Access Compliance Report

Public Rights-of-Way

Intersection ID: 19006	Main Street: CORTLAND_RD	Cross Street: PARK_RD	Location: SW
ADA ID: E46C8796789A	Ramp Type: Perp	Initial Pass/Fail: Fail	Overall Compliance: No
		Severity Score: 25

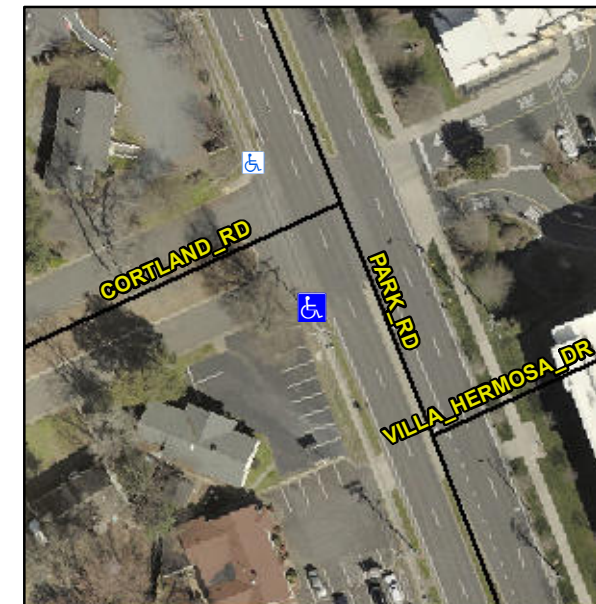
Not Found, R304.5.3

Compliance	Description	Data	Compliance	Description	Data
N/A	Ramp Length (in)	39.0	Yes	Ramp Slope (%)	6.6
Yes	Ramp Width (in)	48.0	No	Ramp XSlope (%)	8.1
N/A	Flare Type LT	N/A	N/A	Flare Type RT	N/A
N/A	Flare Slope LT (%)	N/A	N/A	Flare Slope RT (%)	N/A
N/A	Flare Traversable LT?	N/A	N/A	Flare Traversable RT?	N/A
N/A	Landing Length (in)	N/A	N/A	DWS Provided?	N/A
N/A	Landing Width (in)	N/A	N/A	DWS Contrast?	N/A
N/A	Landing Slope (%)	N/A	N/A	DWS Length (in)	N/A
N/A	Landing X Slope (%)	N/A	N/A	DWS Full Width?	N/A
N/A	Landing Curb? (Y/N)	N/A	N/A	DWS Offset (in)	N/A
N/A	Shared Landing?	N/A			
N/A	Gutter Ponding?	N/A	N/A	Gutter Slope (%)	N/A
N/A	Gutter Lip Ht (in)	N/A	N/A	Gutter X Slope (%)	N/A
N/A	Painted X Walk1?	No	N/A	Painted X Walk2?	N/A
	X Walk 1 Direction	To N		X Walk 2 Direction	N/A
N/A	X Walk 1 Width (in)	N/A	N/A	X Walk 2 Width (in)	N/A
	X Walk 1 Slope (%)	4.0		X Walk 2 Slope (%)	N/A
	X Walk 1 X Slope (%)	0.6		X Walk 2 X Slope (%)	N/A

Remove & Replace Entire Ramp.
